HISTORIC AND DESIGN REVIEW COMMISSION

HDRC CASE NO: 2016-245
ADDRESS: 803 S ST MARYS
LEGAL DESCRIPTION: NCB 738 BLK 1 LOT N IRR 120 OF 1 OR A1,S IRR 51.6 OF N 117 OF 1&2,NE TRI OF 6 OR A7
ZONING: C2 IDZ H
CITY COUNCIL DIST.: 1
DISTRICT: King William Historic District
APPLICANT: Jim Poteet/Poteet Architects, LP
TYPE OF WORK: Installation of awnings
REQUEST:

The applicant is requesting a Certificate of Appropriateness for approval to install awnings install fabric awnings between three column bays on the northwest façade of the structure at 803 S St Mary's.

EXTERIOR ELEVATION: AWNING

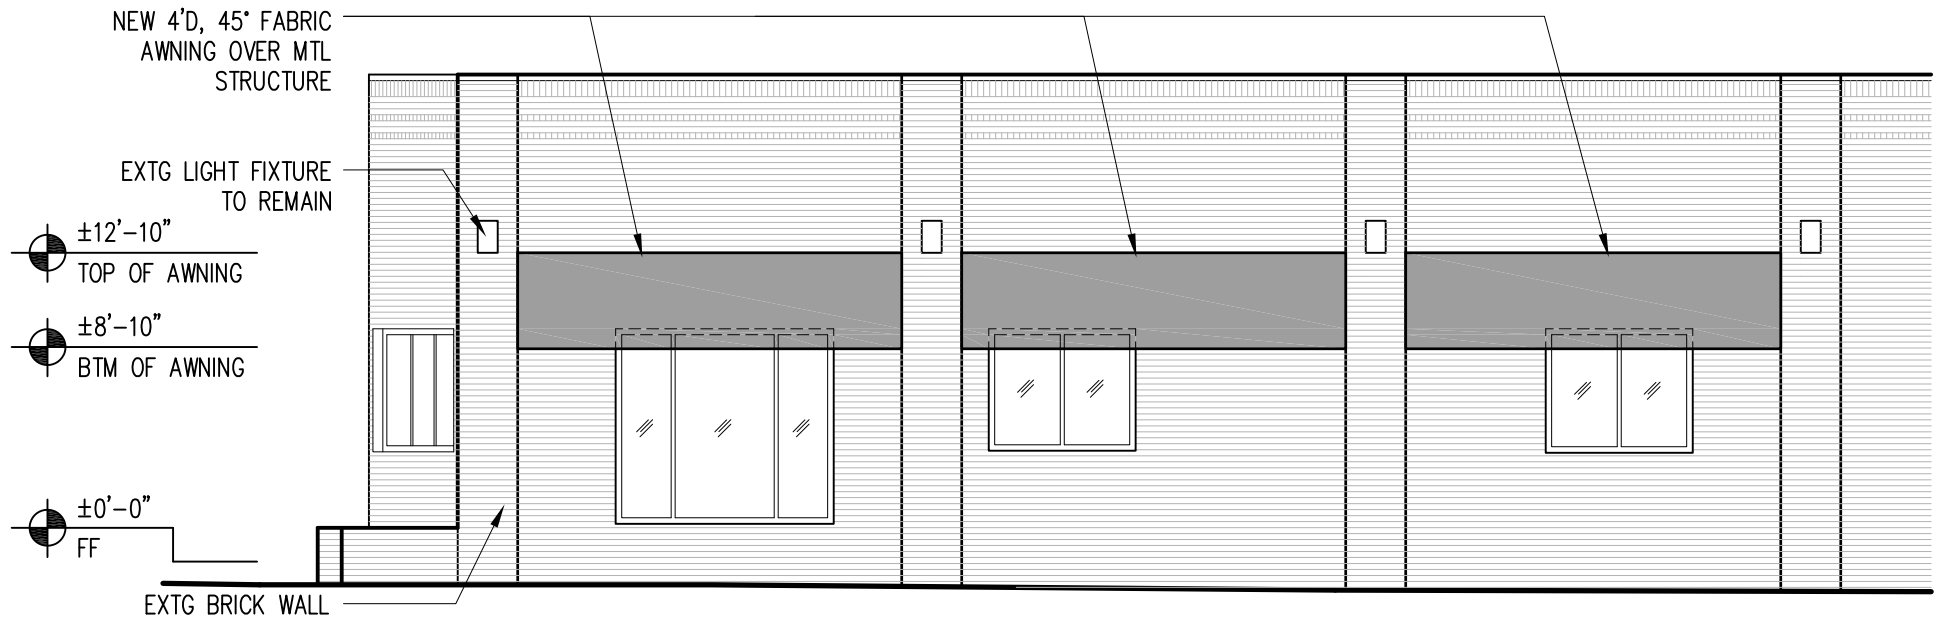
- b. The applicant has proposed to install fabric awnings between three column bays on the northwest façade of the structure at 803 S St Mary's. The proposed awnings will span the entire width of the existing column bays. Staff

finds this appropriate and consistent with the Guidelines.

Staff recommends approval as submitted based on findings a and b.
